Colours Upgrade Report

Phase South
Model Belvoir (50-04) Opt Ground Floor Elev A (MO) (FID)

The Castles of King City Print Date:13-Apr-17

INVENTORY LOT 31S

Lot 31

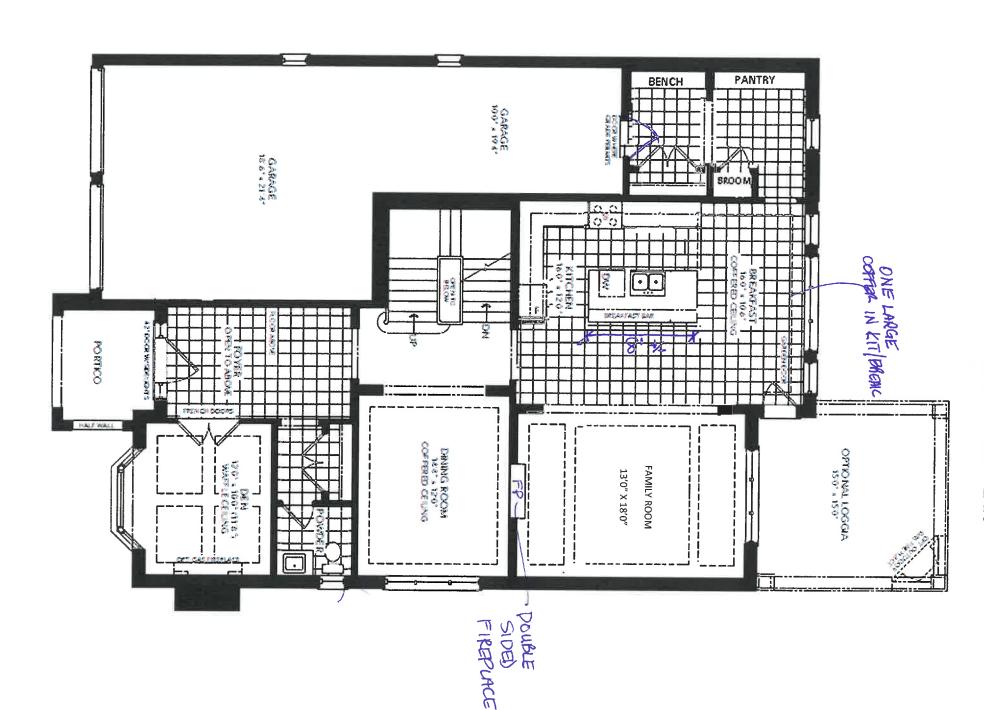
ID	Group	Description	Invoice	Date Ordered	
4931	STRUCTURAL	KITCHEN - SWITCH LCOATION OF FRIDGE AND STOVE	859		
4932	STRUCTURAL	KITCHEN - EXTEND ISLAND TO BE APPROX 8 FEET LONG	859		
4933	STRUCTURAL	LAUNDRY - 1. **RELOCATE LAUNDRY ROOM FROM MAIN FLOOR TO SECOND FLOOR 2. NEW LAUNDRY ROOM TO BE APPROX 9 FEET BY 10 FEET 3. TO INCLUDE STACKABLE WASHER AND DRYER, STANDARD SINK/FAUCET 4. STANDARD UPPER AND LOWER CABINETS WITH COUNTERTOP 5. DOOR TO LAUNDRY TO BE 36 INCHES WIDE	859		
4934	STRUCTURAL	SECOND FLOOR - 1. SHIFT WALL AND ENTRY DOORS AT MASTER BEDROOM, BEDROOM SIZE TO BE APPROX 16 FEET BY 18 FEET 9 INCHES. **ADJUST TRAY TO ACCOMODATE 2. DELETE DRESSER NICH IN MASTER BEDROOM 3. DELETE HIS & HERS WALK IN CLOSET IN MASTER BED 4. MAKE PRIVATE STUDY INTO ONE LARGE WALK IN CLOSET APPROX 19 FEET 9 INCHES BY 10 INCHES WITH BENCH UNDER WINDOW 5. CREATE A HALLWAY TO LAUNDRY ROOM (APPROX 4 FEET WIDE) WITH TRIMMED ARCH 6. **WINDOW TO BE SAME SIZE AS NEW MUD ROOM TO BE CENTRED AND BE THE SAME WIDTH AS PRIVATE STUDY **APPROX 40 INCHES WIDE	859

4935	STRUCTURAL	NEW MUD ROOM (FORMER LAUNDRY) - 1. DELETE DOOR FROM BREAKFAST AREA, KEEP TRIMMED ARCHWAY 2. ADD 12 INCH DEEP PANTRY APPROX 6 FEET WIDE 3. ADD SINGLE DOOR BROOM CLOSET 4. ADD TRIMMED ARCHWAY BETWEEN PANTRY AREA AND MUD ROOM 5. ADD CAPPED BENCH IN MUDROOM 6. DOUBLE DOOR CLOSET TO REMAIN 7. DELETE GARDEN DOOR 8. WINDOW IN LAUNDRY TO CENTRED AND BE THE SAME WIDTH AS PRIVATE STUDY **APPROX 40 INCHES WIDE	859		
4940	STRUCTURAL	FRAMING / TRIM - FAMILY ROOM 1. DELETE HALF WALLS AND COLUMNS BETWEEN FAMILY AND KITCHEN 2. INSTALL FULL HEIGHT NIB WALLS AT ETHER END OF FAMILY ROOM, APPROX 30 INCHES WIDE, MAKING ROOM BESIDE FIREPLACE FOR FUTURE OPTIONAL BUILT-INS 3. INSTALL TRIMMED FLAT ARCH 4. REVISED WAFFLE CEILING - INSTALL A 3 PANEL WAFFLE	859		
4941	STRUCTURAL	FRAMING / TRIM - DINING ROOM 1. DELETE HALF WALL AND COLUMNS 2. INSTALL FULL HEIGHT NIB WALLS, APPROX 30 INCHES WIDE	859		
4942	STRUCTURAL	FRAMING - KITCHEN BREAKFAST 1. INSTALL ONE LARGE COFFERED	859

4949	STRUCTURAL	SOUND INSULATION TO LAUNDRY ON 2ND FLOOR	859		
4957	STRUCTURAL	WINDOWS - BASEMENT WINDOWS BUILT AS IS	859		
4958	MODIFIED PLAN	******MODIFIED PLAN	859

5013	COLOURS	ADD WINDOW IN LAUNDRY ROOM ON SECOND FLOOR ABOVE SINK	868	
5041	STRUCTURAL	ADD WINDOW IN LAUNDRY ROOM ON SECOND FLOOR ABOVE SINK	859	
5042	STRUCTURAL	FIREPLACE - DINING / FAMILY 1. L-38 DOUBLE SIDED FIREPLACE, APPROX 20-24 INCHES OFF FINISHED FLOOR, NO MANTLE REQUIRED, STANDARD BLACK TRIM KIT ON BOTH SIDES 2. FIREPLACE TO BE FLUSH ON DINING ROOM SIDE 3. BUILD FLOOR TO CILING BOX ON GREAT ROOM SIDE WITH APPROX 6 INCHES ON EITHER SIDE OF FIREPLACE	859
